# **City of Melbourne's Submission**

Review of the Draft World Heritage  
Strategy Plan for the Royal Exhibition  
Building and Carlton Gardens World  
Heritage Environs Area

**11 November 2022**

**Figure 1: Location of the Royal Society Site relative to REB and CG**

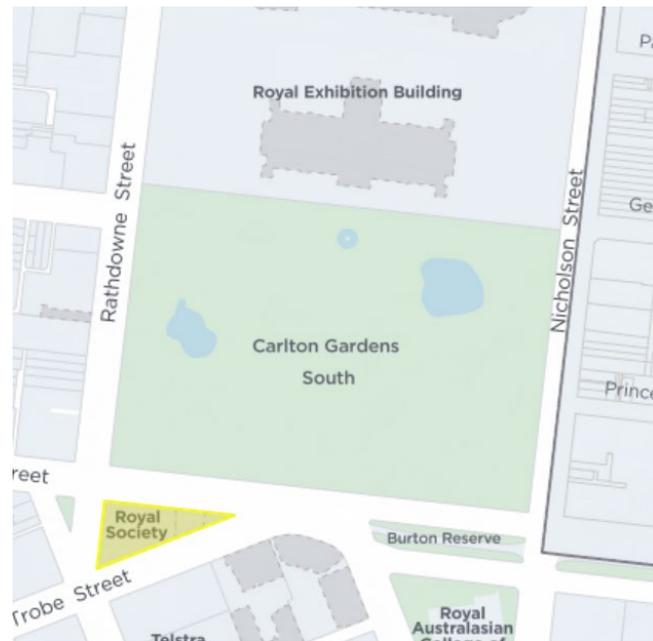
9. No controls are proposed for the Royal Society site as part of the Draft Amendment.
10. Council submits the absence of built form planning controls for the Royal Society Site could present a risk to the WHEA.
11. The Royal Society of Victoria building, caretakers cottage and weather station (1-9 Victoria Street, c.1858, VHR H0373) are sited on a wedge of land bounded by Victoria, La Trobe and Exhibition Streets (**Royal Society Site**) as shown in yellow in Figure 1 below.

14. Nevertheless, notwithstanding the VHR protection, given its location immediately opposite of the REB and CG on the south side of the Victoria Street carriageway, Council submits it is necessary to reconsider applying a Design and Development Overlay (DDO) protection on the Royal Society Site.

Figure 3: Map 1 included in the proposed Schedule to Clause 43.02

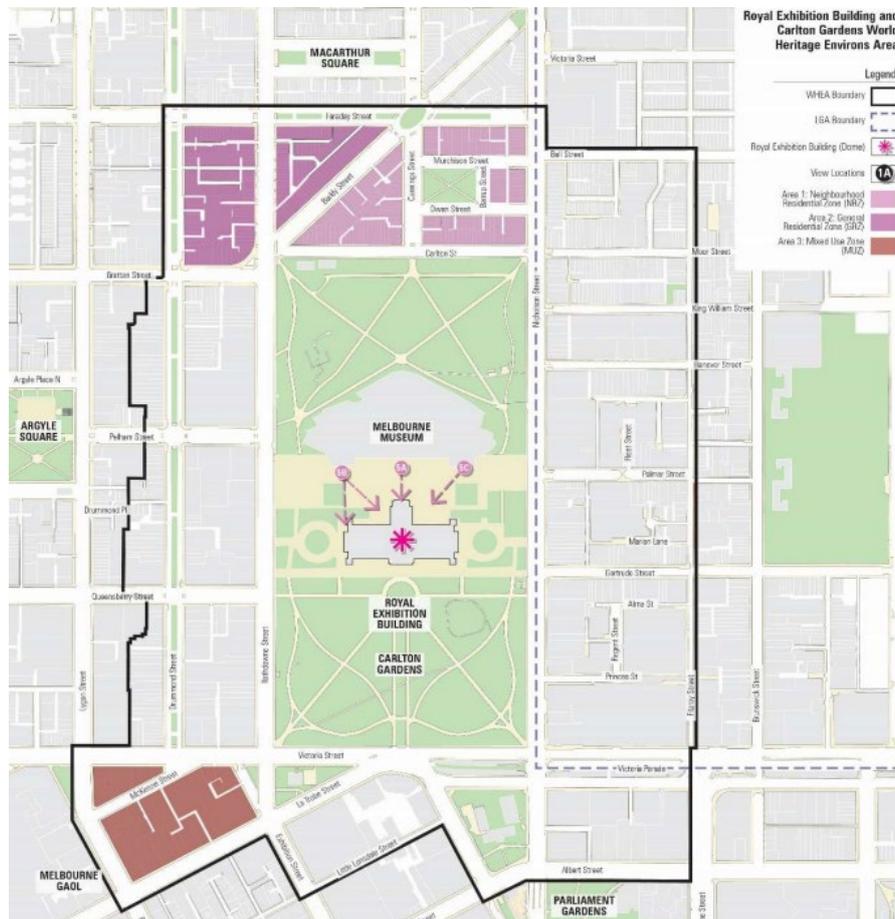
17. Council considers that height controls to protect views of this area from the REB are warranted but require further work to justify the nature and drafting of the controls.

- (a) The 'Southern boundary' area is largely committed (tall buildings plus approved permits) with multiple examples puncturing the skyline.
  - (b) To the east of the 'Southern boundary' area directly south of the Royal Society Site there exists an intense Central City backdrop that must be acknowledged.

- (c) The supporting strategic material with views from points 5A, B and C from the Museum Forecourt (see Map above) appears to indicate that the existing towers in the 'Southern boundary' area currently do not impact the skyline behind the dome and drum. However, these views are at three specific points. They, therefore, can be regarded as theoretical viewpoints in that the totality of views in the general direction of a southerly arc should be tested. Further, the visibility of the 'Southern boundary' area buildings needs to be analysed in relation to the total backdrop of tall buildings directly to the south – in the block bounded by La Trobe, Lt Lonsdale, Spring, and Exhibition Streets and those further south in the Central City– to determine the possible impact of the buildings in the 'Southern

boundary' area in relation to the totality of the city backdrop. Should the above analysis indicate that height controls over the 'Southern boundary' area are needed, a further piece of work should be undertaken to determine whether it is appropriate to apply the proposed range of preferred and mandatory heights or if a blanket height across the area would be as effective.

**Figure 5 – Existing zoning map of area north of Carlton Street**

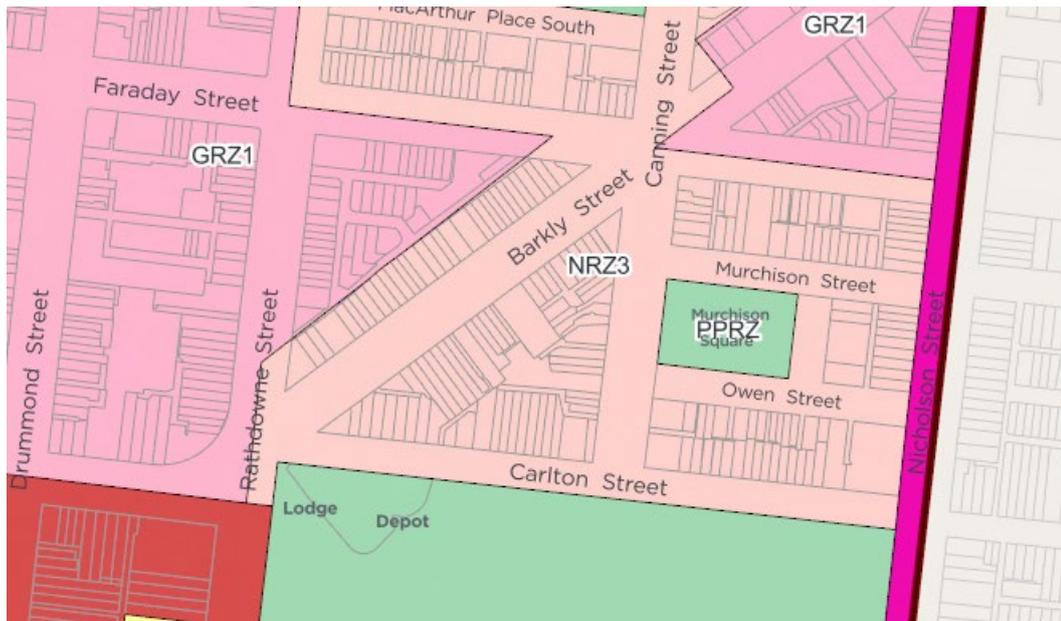
29. A discrepancy has been identified between Council’s zoning map below and the depiction of the land use zoning at Map 1 (as taken from the Draft Strategy Plan) regarding land on the north-west side of Barkly Street between Canning and Rathdowne Streets. The land is actually within a NRZ (Council mapping), not a GRZ as (shown in the Draft Amendment) – a matter that needs to be, and can be corrected in the final plan.

30. In Council’s submission, an additional height restriction in the form of a DDO to this area to the north of the WHEA is both unwarranted and unnecessary.

**Figure 8 – Rathdowne Street, Aerial, April 2022 illustrating DDO6 gap area**  
*Source: CoMPass*

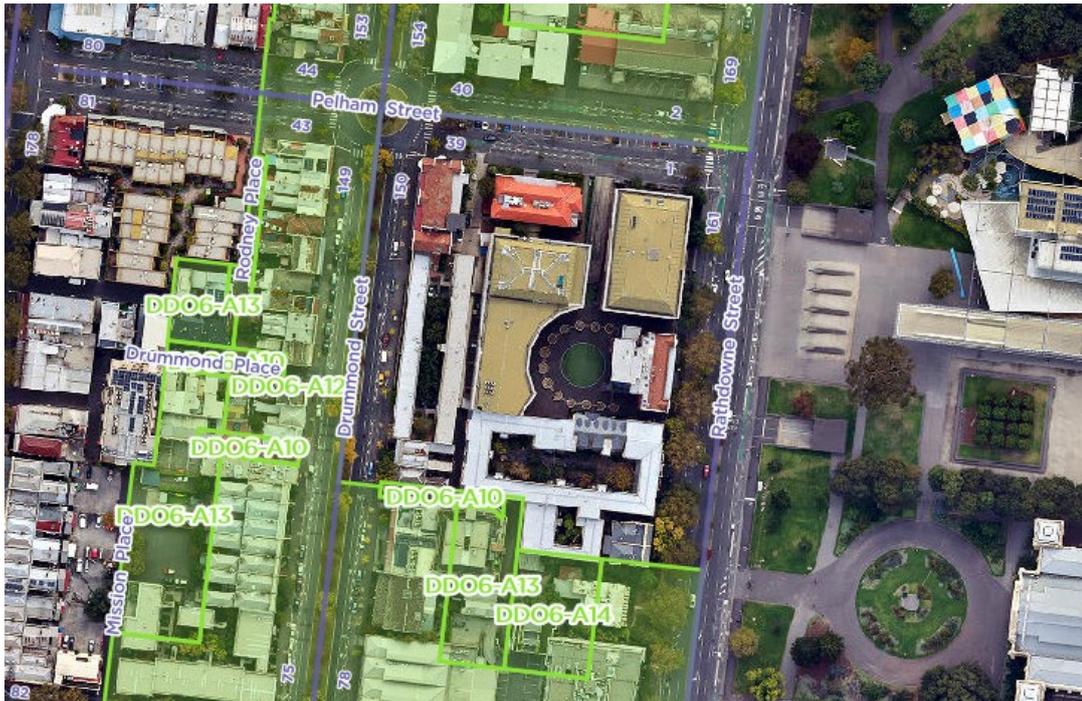
33. This is because:
  - (b) Rathdowne Street being the principal corridor immediately to the west of the WHEA has an immediate and direct interface with the REB and CG.
  - (c) the large properties in the pocket immediately to the south of Pelham Street (see Figure 8 below) are not affected by any built form overlays.

34. However, in Council’s submission, the Rathdowne Street physical context is a strong candidate for the application of mandatory provisions on the basis of heritage and character value. DDO6 is presently drafted with discretionary height controls.

35. Further analysis should be carried out taking into consideration the impact of development on the consistent, low scale heritage streetscape of Rathdowne Street in its entirety.
